Project	IEEE 802.16 Broadband Wireless Access Working Group < http://ieee802.org/16 >
Title	IEEE 802.16m System Deployment Scenarios with Multi-carrier Support and Clarification on Multi-carrier Frame Structure
Date Submitted	2008-09-09
Source(s)	I-Kang Fu, Yih-Shen Chen, Kelvin Chou, IK.Fu@mediatek.com Dora Chen, Stanley Hsu, Pei-Kai Liao, Yu-Hao Chang, Paul Cheng MediaTek Inc. No.1, Dusing Rd. 1, Hsinchu Science Park, Hsinchu, Taiwan, R.O.C.
Re:	IEEE 802.16m-08/033, "Call for Contributions and Comments on Project 802.16m System Description Document (SDD)," ◆ PHY: Multi-Carrier Operation
Abstract	This contribution investigates the possible scenario for IEEE 802.16m network deployment. Due to the restriction by backward compatibility when co-deployed with IEEE 802.16e network, the frequency channel bandwidth, center frequency and channel raster shall be the same as the parameters used in IEEE 802.16e based mobile WiMAX system.

IEEE 802.16m System Deployment Scenarios with Multi-carrier Support and Clarification on Multi-carrier Frame Structure

Figure 5 Confusion on the definition on multi-carrier MS and wider bandwidth MS due to the confusing drawing in current SDD

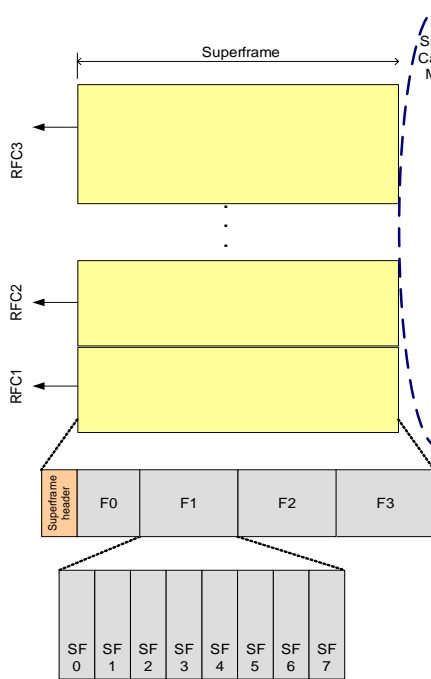
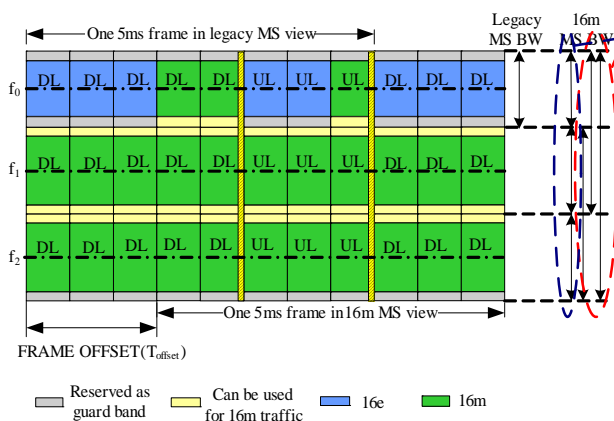
Consider the case depicted in Figure 4, it's very confusing that whether the multi-carrier frame structure or the frame structure with wider bandwidth support should be applied? Figure 5 put the current figures in SDD for comparison to show how people may confuse on the definitions on “multi-carrier” and “wider bandwidth”.

The drawing for multi-carrier MS in Fig.18 is the same as the drawing for 16m MS with wider BW support.

This will definitely confuse people the definitions on “multi-carrier” and “wider bandwidth”

The drawing for single carrier MS in Fig. 18 is also the same as the 16m MS with wider BW support in Fig. 22.

This will confuse people what is the definition of “wider bandwidth”

Figure 6 Proposed modifications to clarify the definitions on multi-carrier and wider bandwidth support

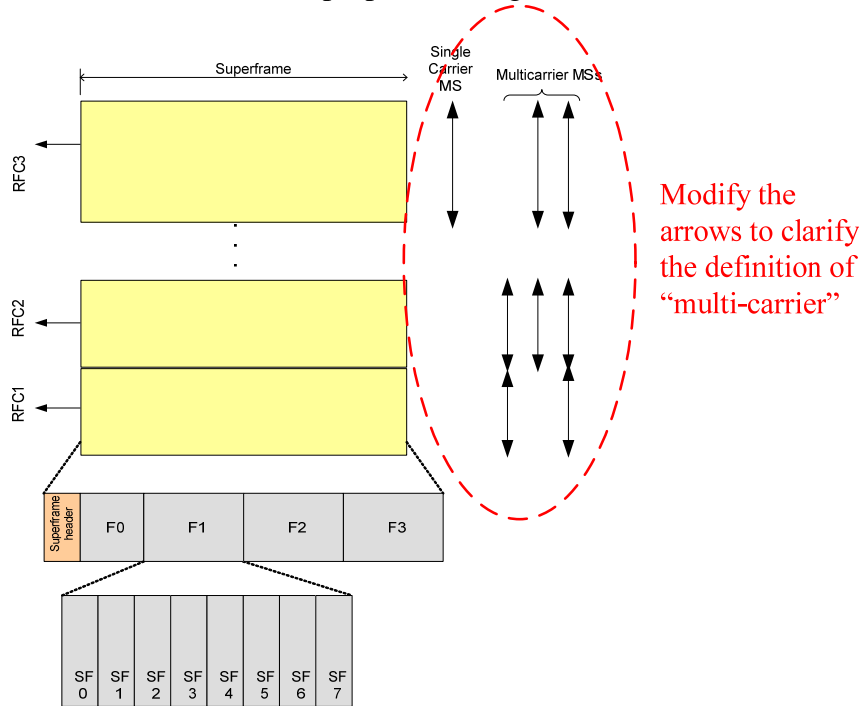
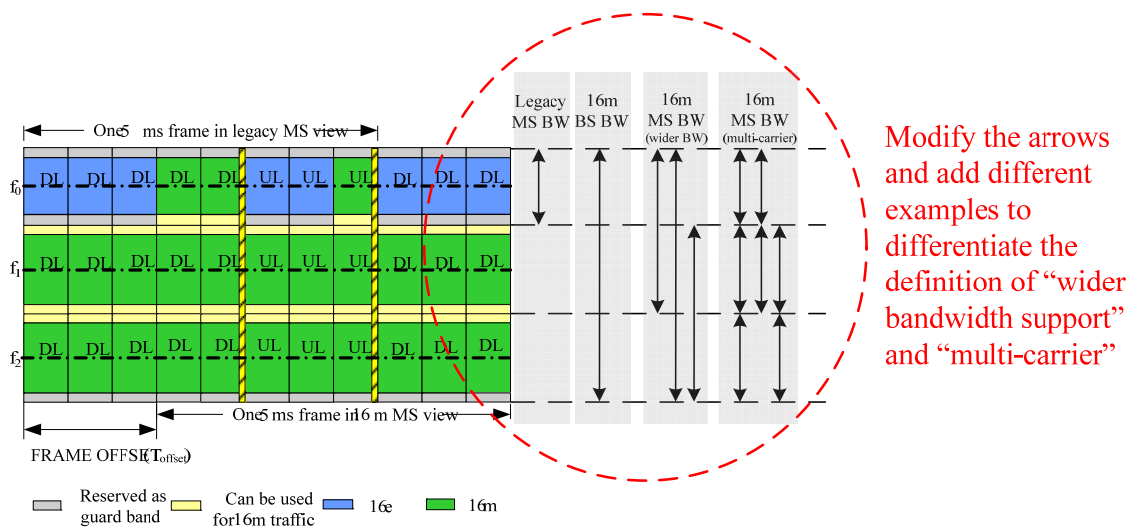
In addition to the confusion on multi-carrier MS and the MS with wider bandwidth support, the frame structures will also confuse people what is the meaning of the wider bandwidth support. Because both Figure 18 and Figure 22 in SDD specifies multiple frequency channels, and both of them actually looks like multi-carrier frame structure. A simple method to resolve the confusion is adding the lines to indicating the 16m BS bandwidth in the frame structure with wider bandwidth support. This can help people understand the definition of wider bandwidth defined in IEEE 802.16m.

In order to resolve the confusions in current SDD without largely revise the current SDD text, the slightly modified frame structures is proposed in Figure 6 for clarification.

Figure 18 Example of the frame structure to support multi-carrier operation

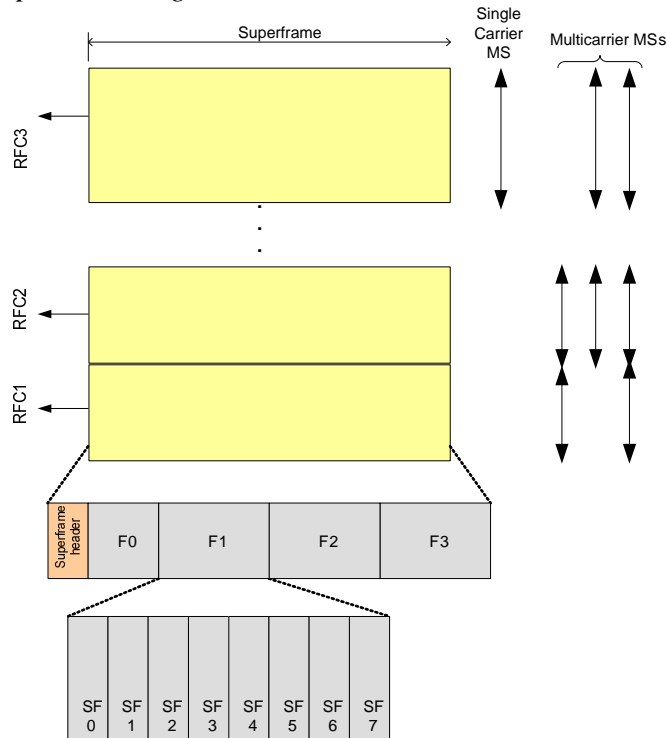
[Use the following figure to replace the Figure 18 in 802.16m-08/003r4]

Figure x Example of the frame structure to support multi-carrier operation and backward compatibility

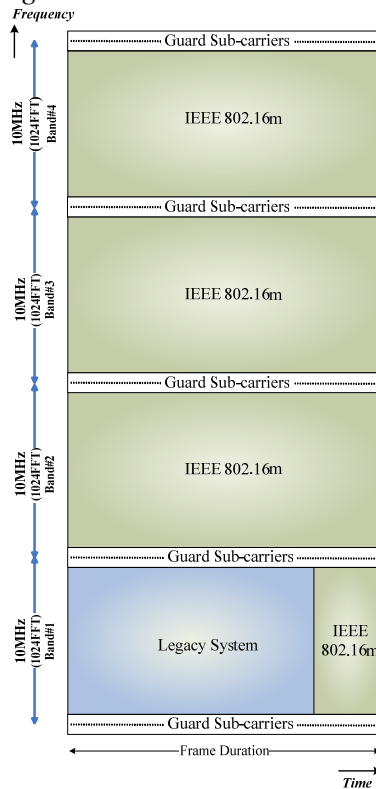
[Add the following figure after line#19, page#35 in 802.16m-08/003r4]

Figure 22 Illustration of frame structure supporting legacy frames with a wider channel

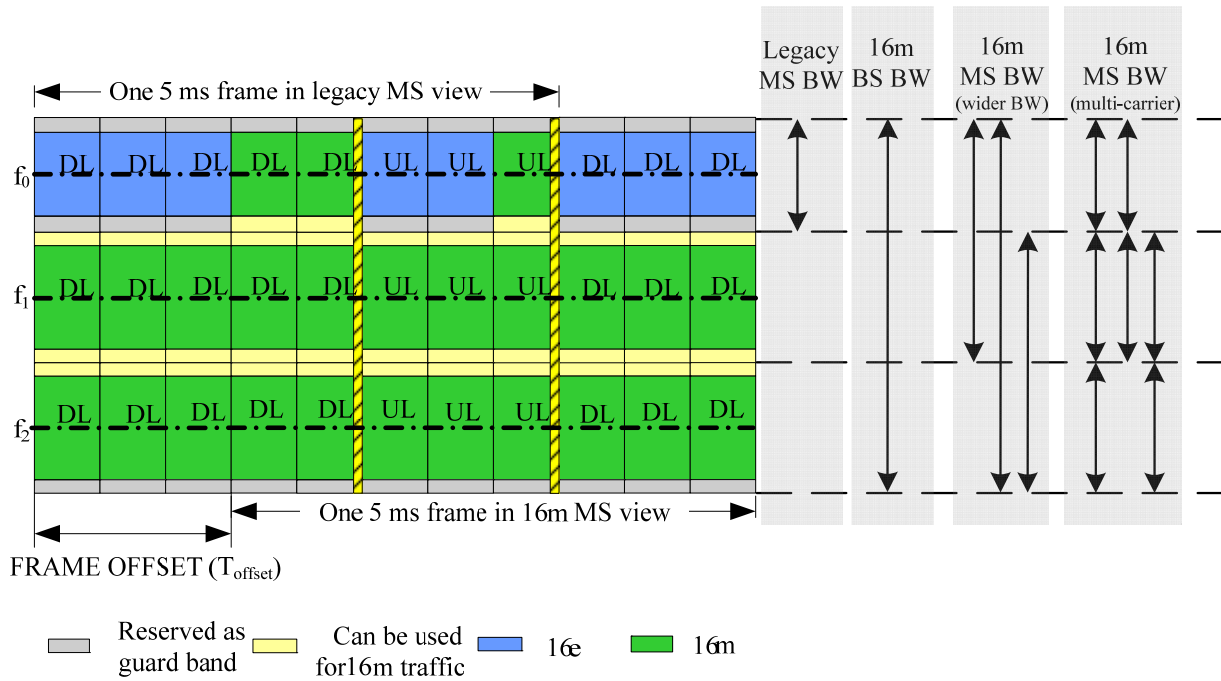
[Use the following figure to replace the Figure 22 in 802.16m-08/003r4]
